BL417 Geological Sciences Phase 2 F100 IGWS East
(F100) Lab Renovations
IU 20250361

ADDENDUM NO. 2
14217

20 March 2026

FIFTH FLOOR
DEMOLITION PLAN
A151

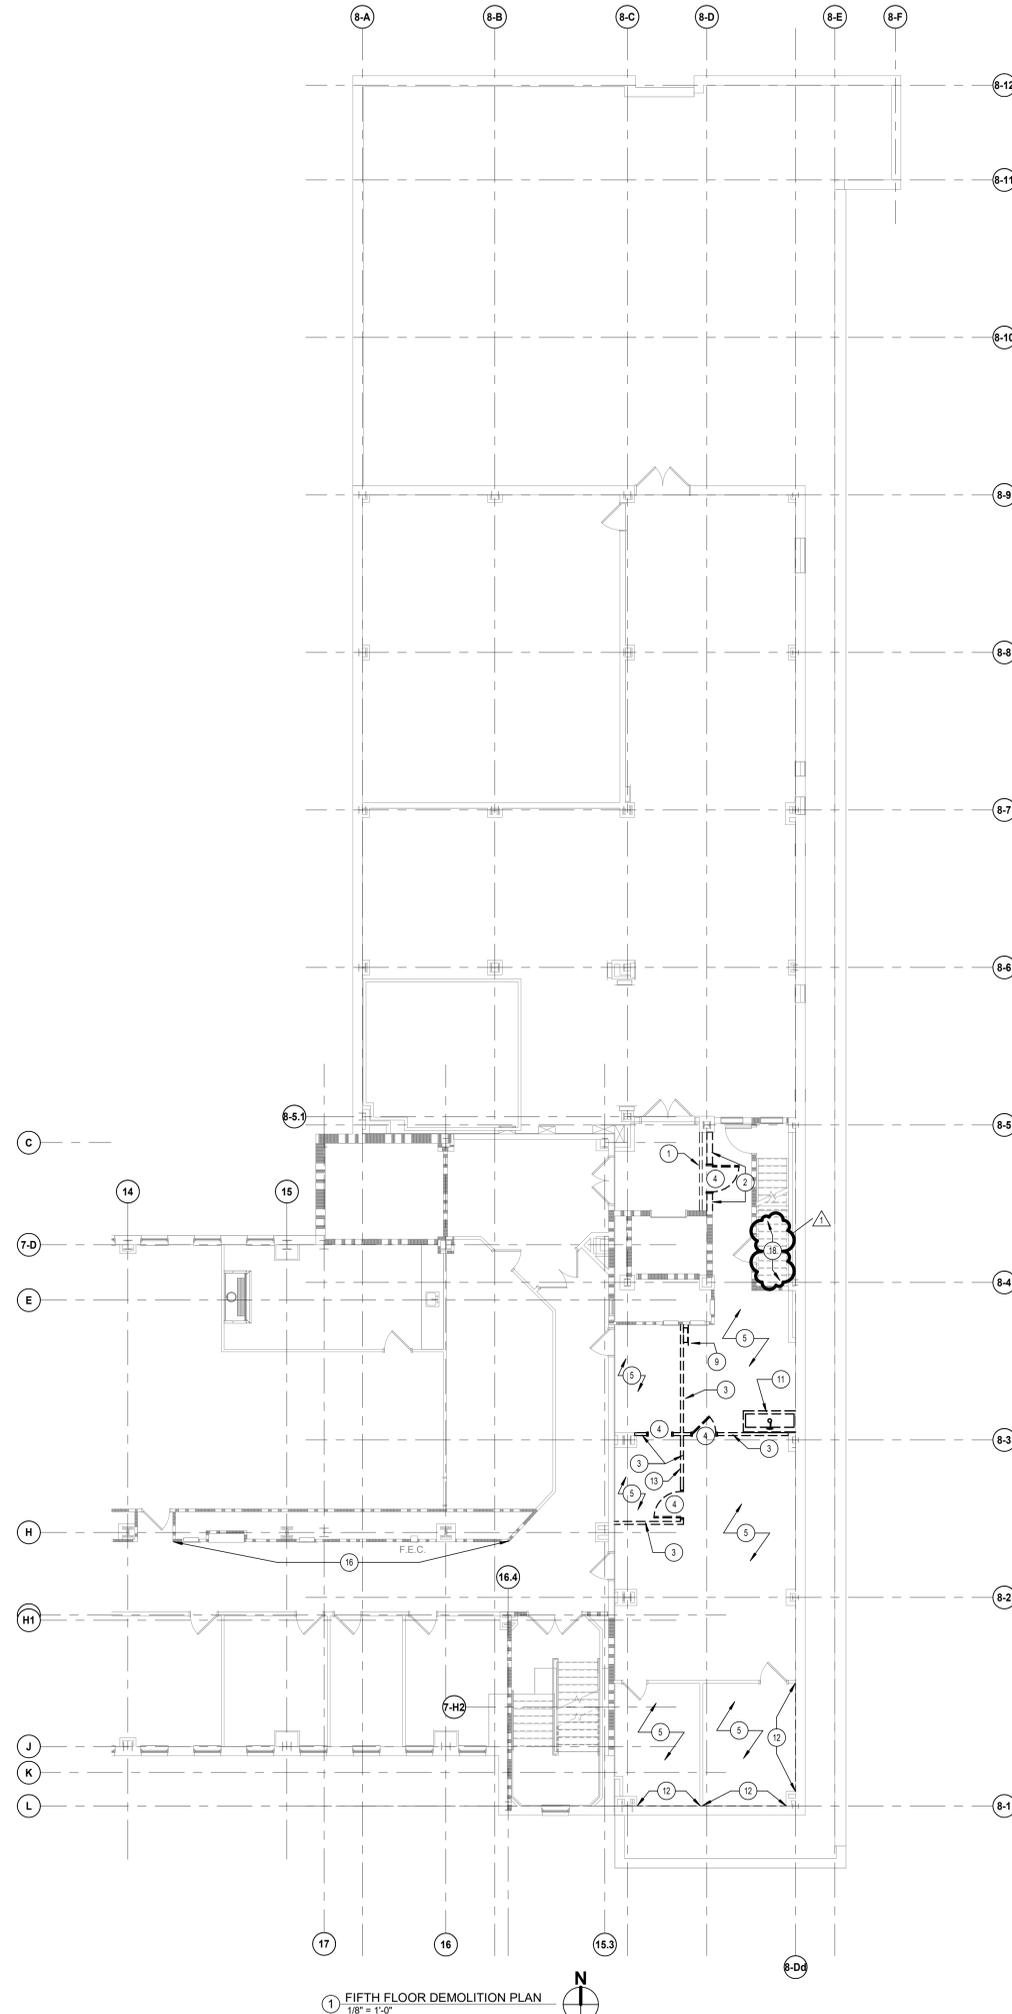
1. Sheet A151 - Fifth Floor Demolition Plan
 - a. Add Specific Demolition Plan Note 18 to the closet underneath the stair, as shown on attached revised sheet.

FIRST FLOOR PLAN
A211

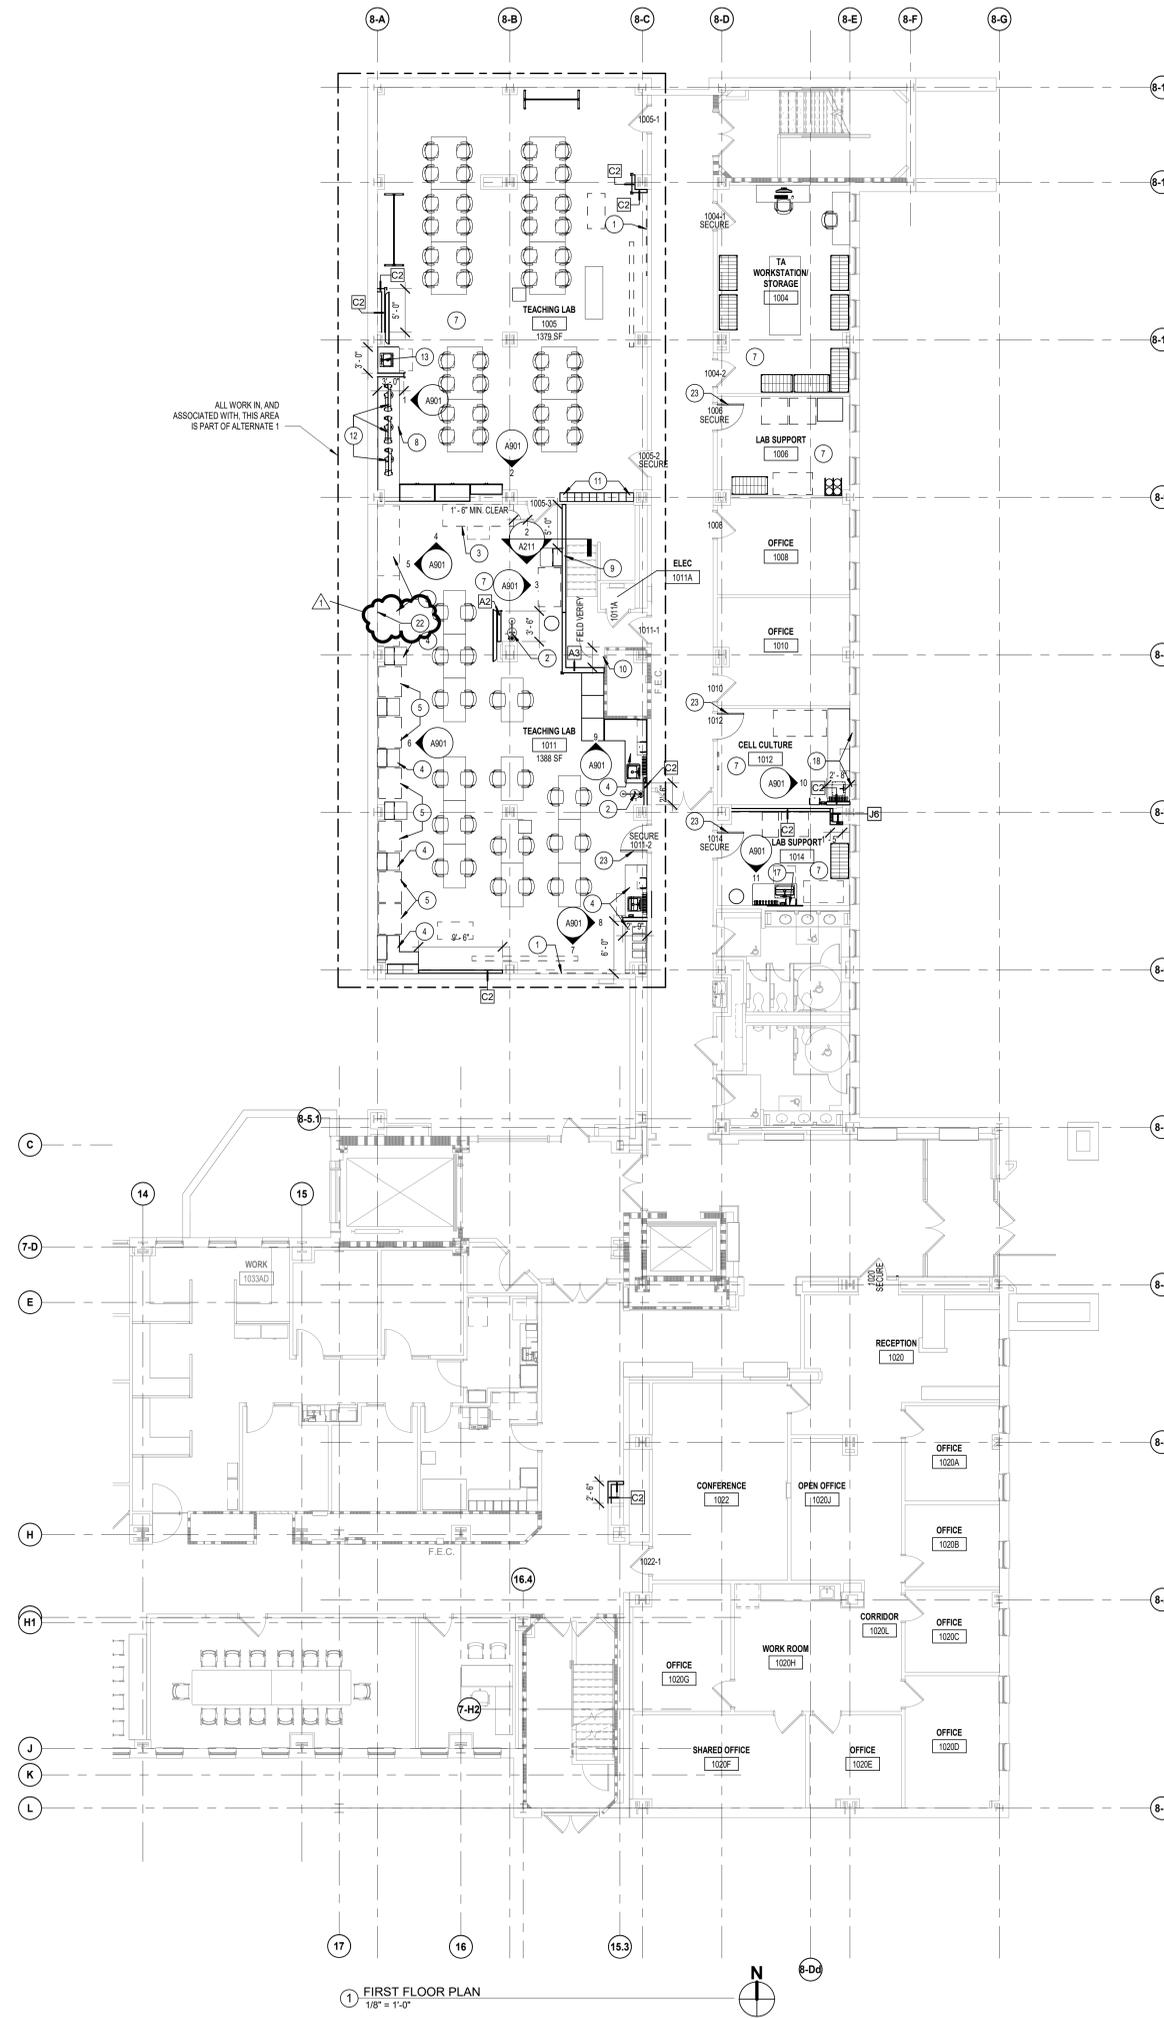
2. Sheet A211 - First Floor Plan
 - a. Add Specific Floor Plan Note 22 to Teaching Lab 1011 as shown on attached revised sheet. The intent is for new concrete block to be installed in existing exterior wall where missing.

THIRD FLOOR PLAN
A231

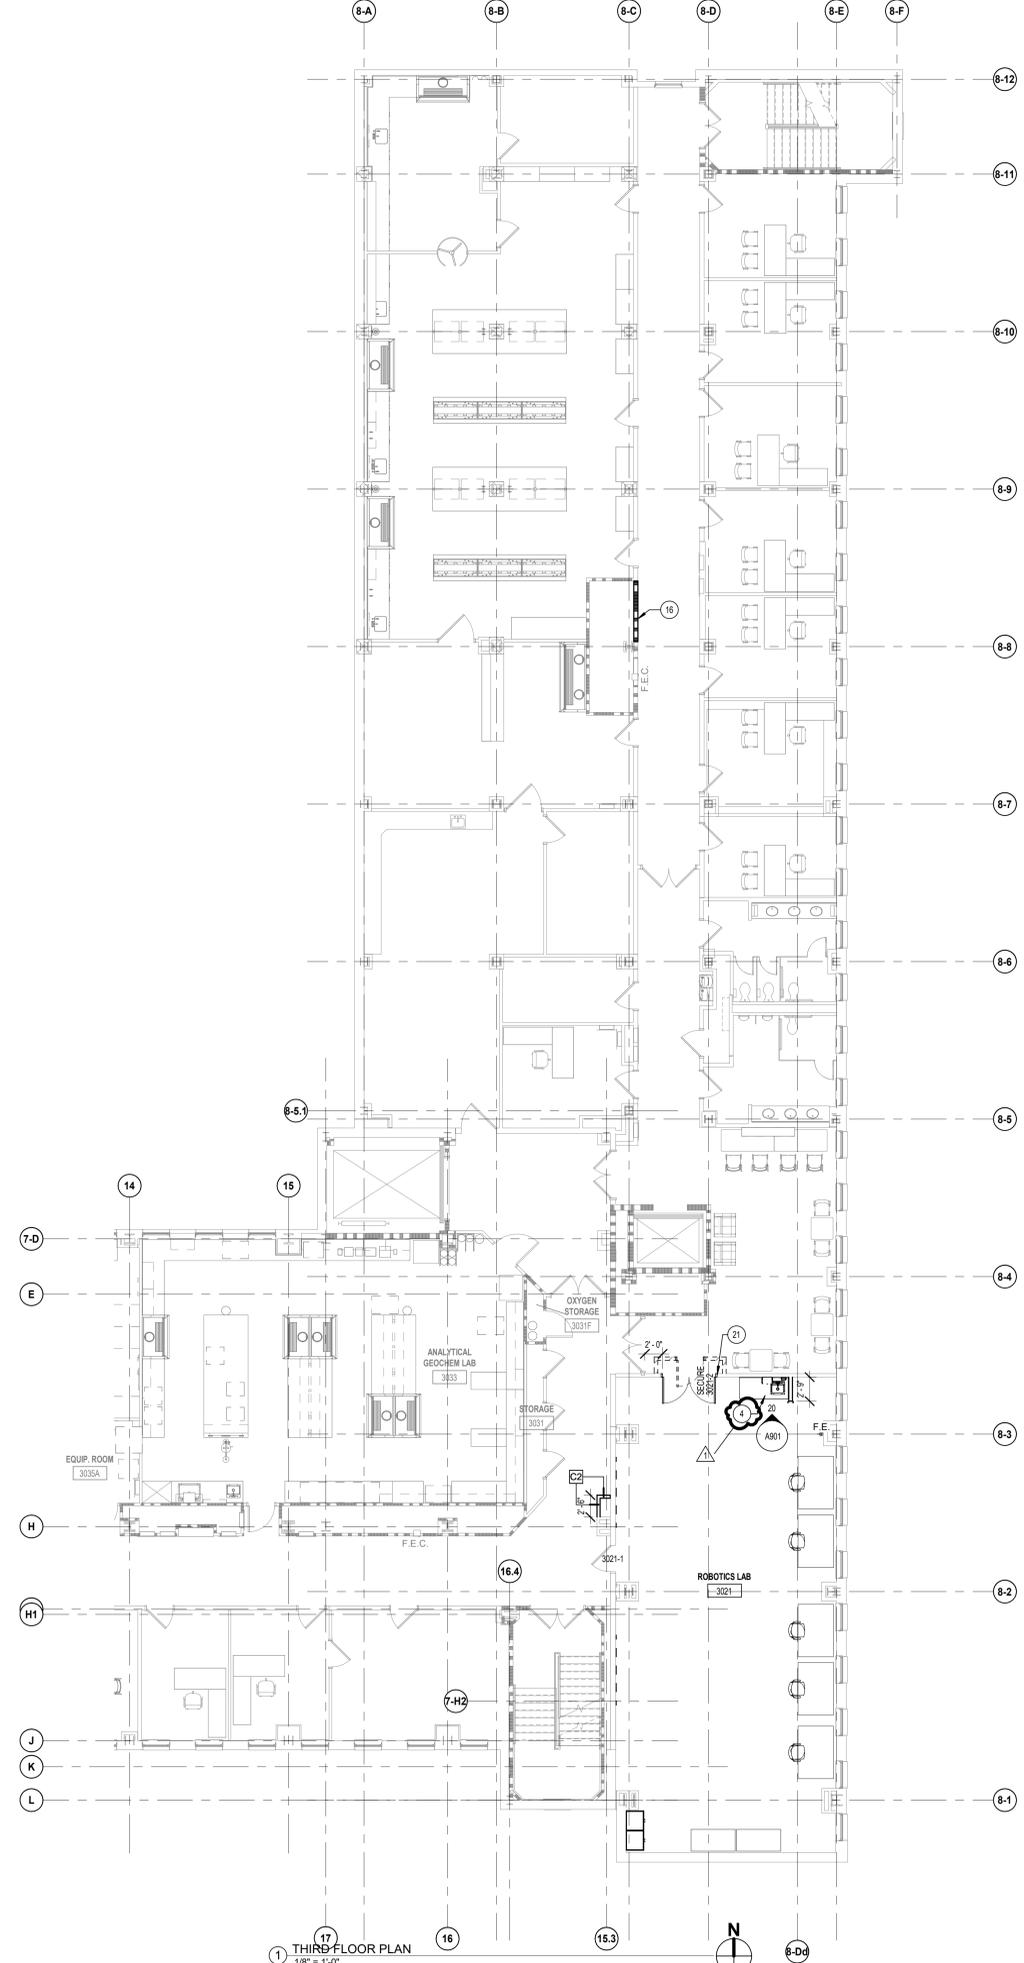
- Q.** Where specific plan notes and elevations differ on countertop which will override? e.g. plan note #8 on A231; Robotics lab 3012; 20/A901) regarding

what type of countertop to use (chem resistant phenolic or ESD laminate, or epoxy and phenolic after looking at this set of bid documents.

3. Sheet A231 - Third Floor Plan
 - a. Revise Specific Floor Plan Note indicating casework materials to note 4, as shown on attached revised sheet.
4. Sheet A821 - Second Floor Reflected Ceiling Plan

A. Plans and elevations are intended to be complimentary, neither overrides the other. Provide Architect with specific discrepancies. Refer to attached revised sheet A231 for clarification on Robotics lab 3012.

SECOND FLOOR
 REFLECTED
 CEILING PLAN
A821

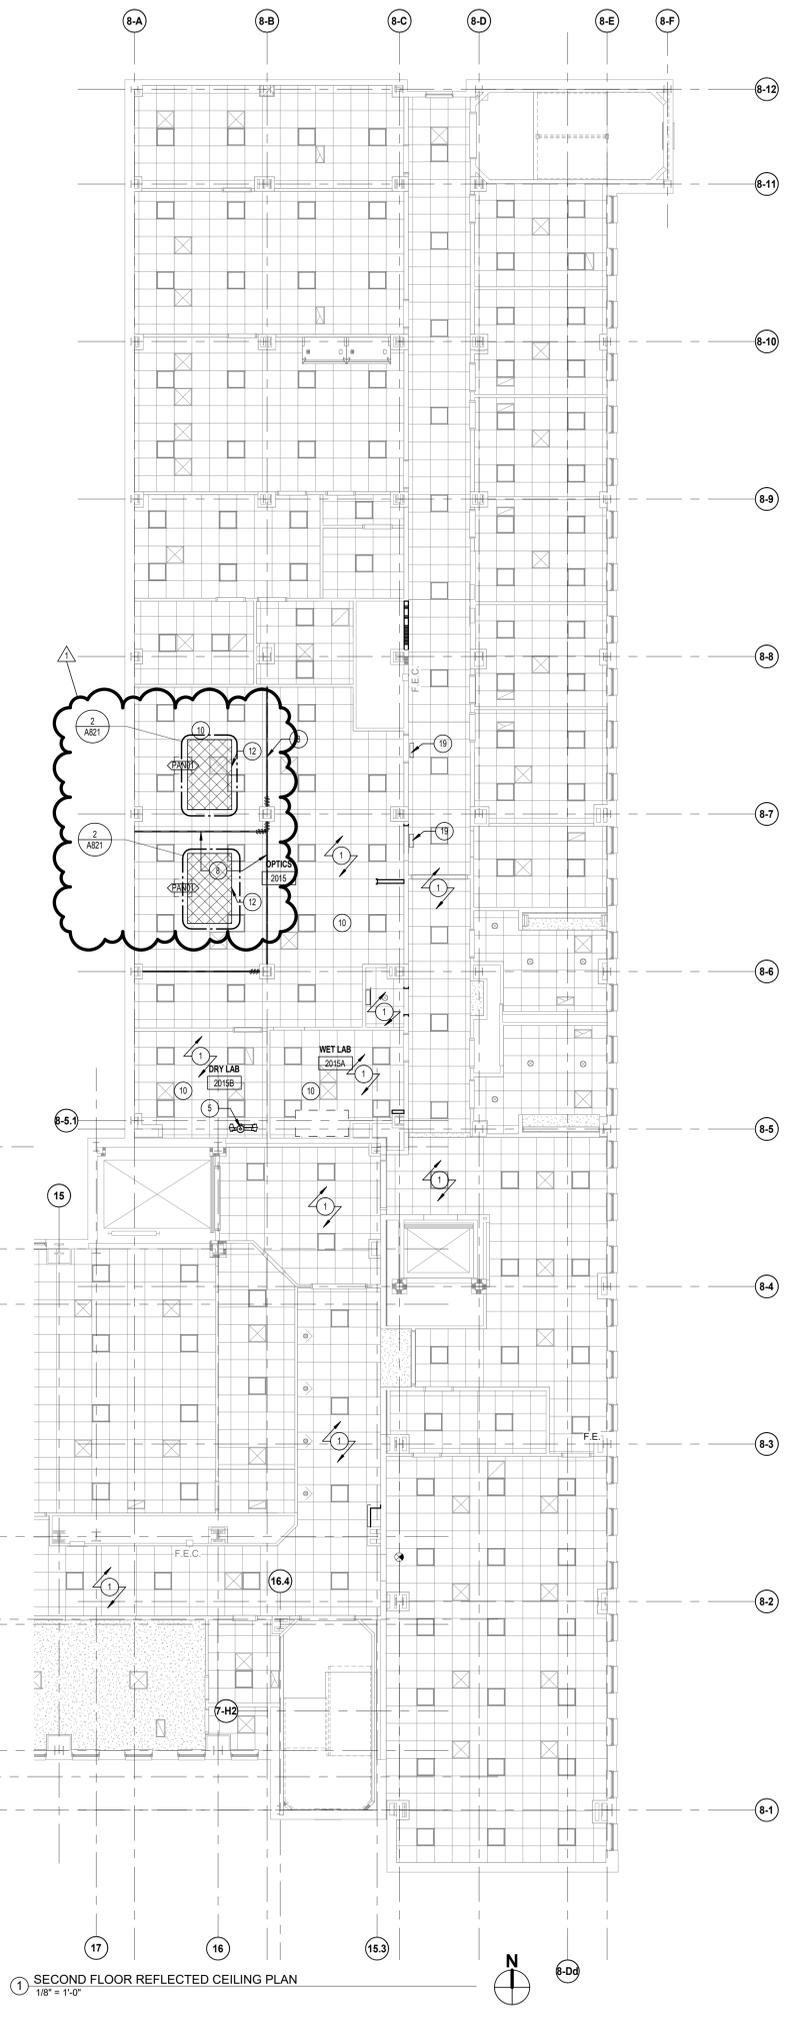
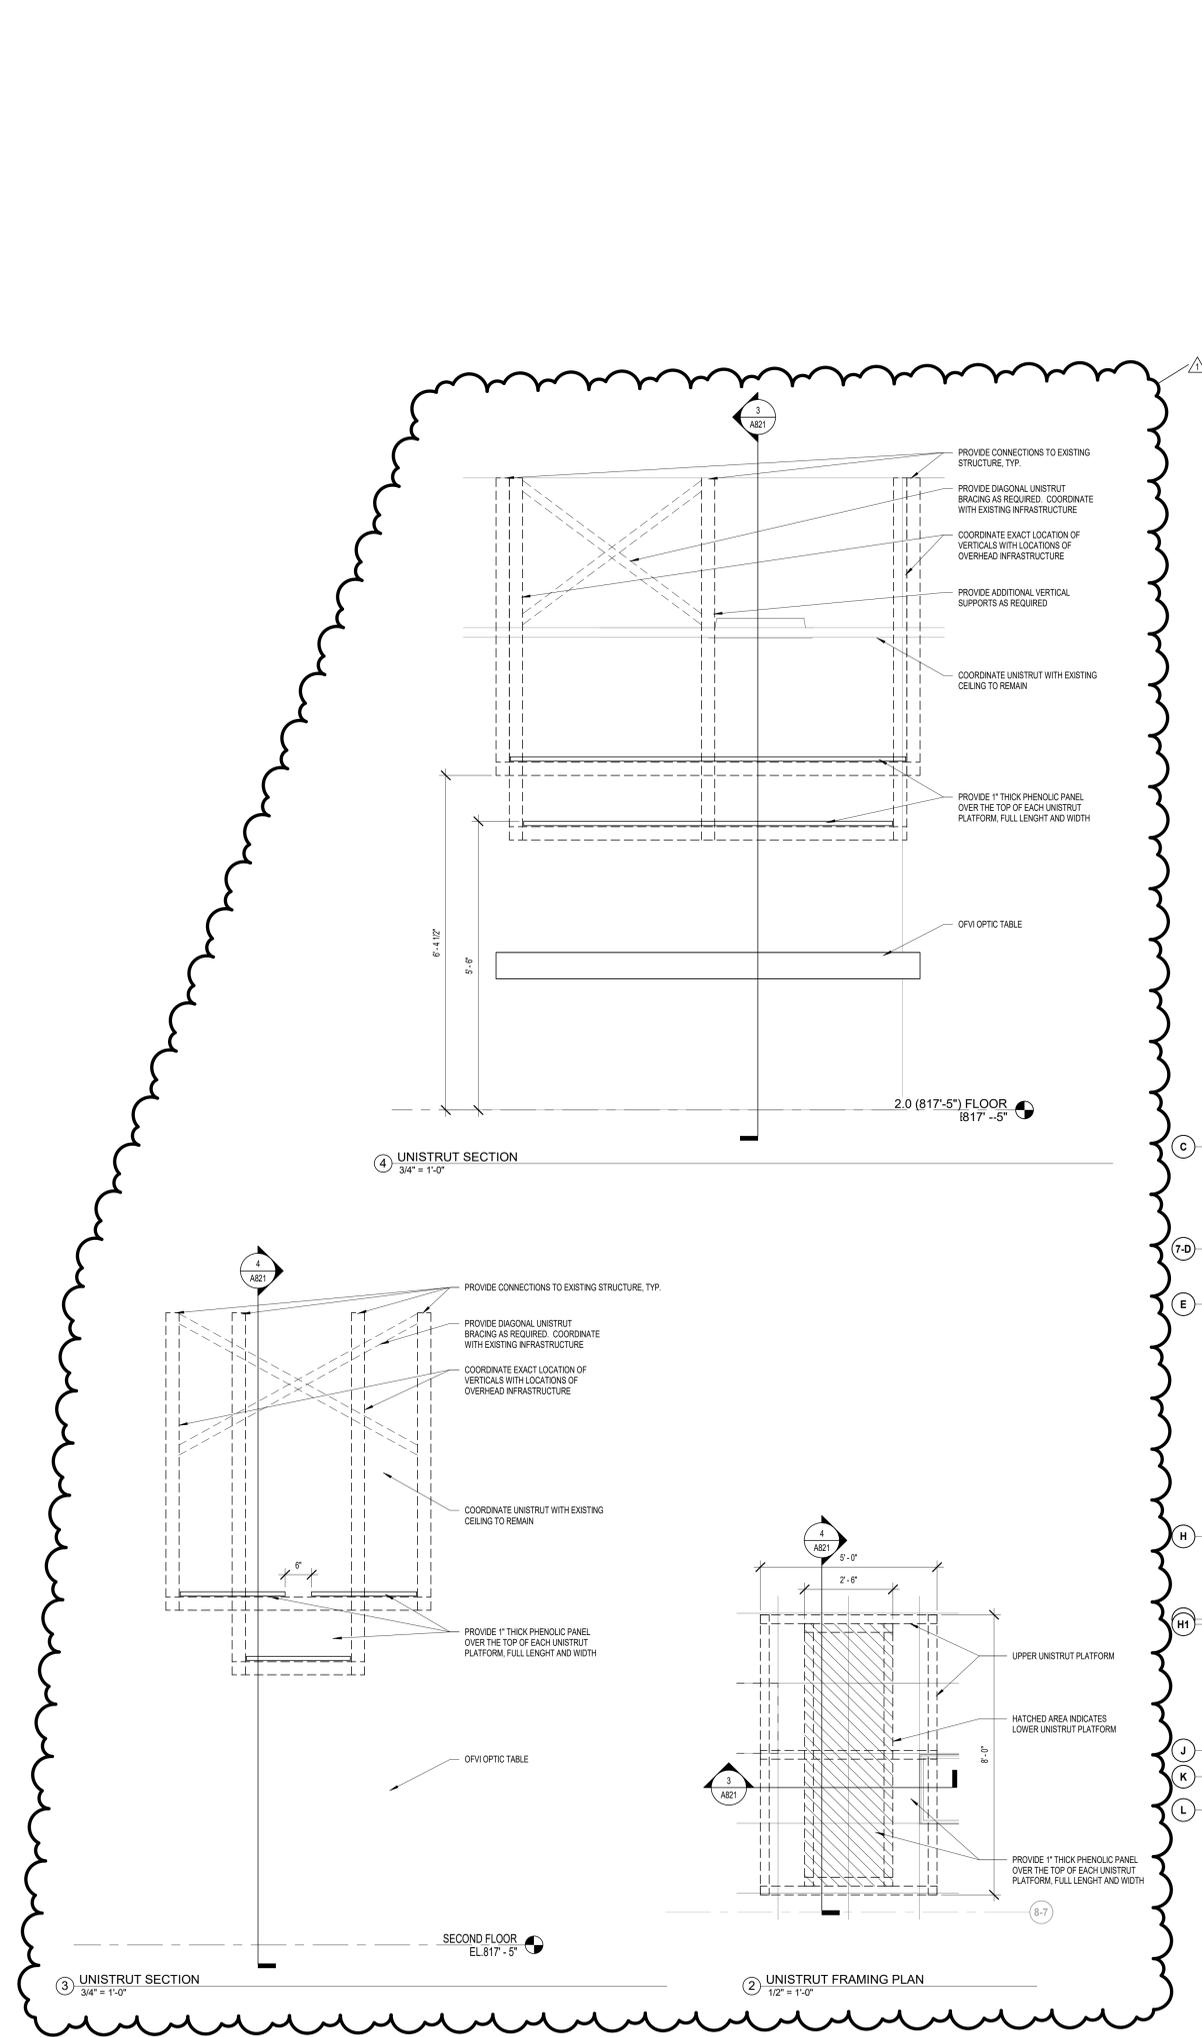
- a. Add Specific Reflected Ceiling Plan Note 12 to read as follows:
"12. HATCHED AREA INDICATES LOCATION OF CFCI UNISTRUT SUPPORT SYSTEM. CONTRACTOR TO PROVIDE DELEGATED DESIGN OF THE UNISTRUT SUPPORT SYSTEM, DESIGNED AND STAMPED BY A PROFESSIONAL ENGINEER EXPERININCED IN DESIGN OF THIS WORK AND LICENSED IN THE STATE OF INDIANA. EACH UNISTRUT SYSTEM IS TO BE DESIGNED TO SUPPORT 1,000 LBS. REFER TO DETAIL A821_2 FOR ADDITIONAL INFORMATION."

- b. Add Specific Reflected Ceiling Plan Note 12 to Optics 2015 as shown on attached sheet.
 - c. Add enlarged Unistrut Framing Plan A821_2 in its entirety, as shown on attached sheet.

- d. Add section details A821_3 and 4 in their entirety, as shown on attached sheet.
5. Sheet EQ211 - First Floor Equipment Plan
 - a. Add Specific Equipment Plan Note 5 to read as follows:
"5. CFCI WIRE SHELVING WITH 74" POSTS ON 5" CASTERS, AND SOLID STAINLESS STEEL BOTTOM SHELF - SIMILAR TO INTERMETRO INDUSTRIES CORPORATION, SUPER ADJUSTABLE SUPER ERECTA. PROVIDE 2 LOCKING CASTERS PER SHELVING UNIT."
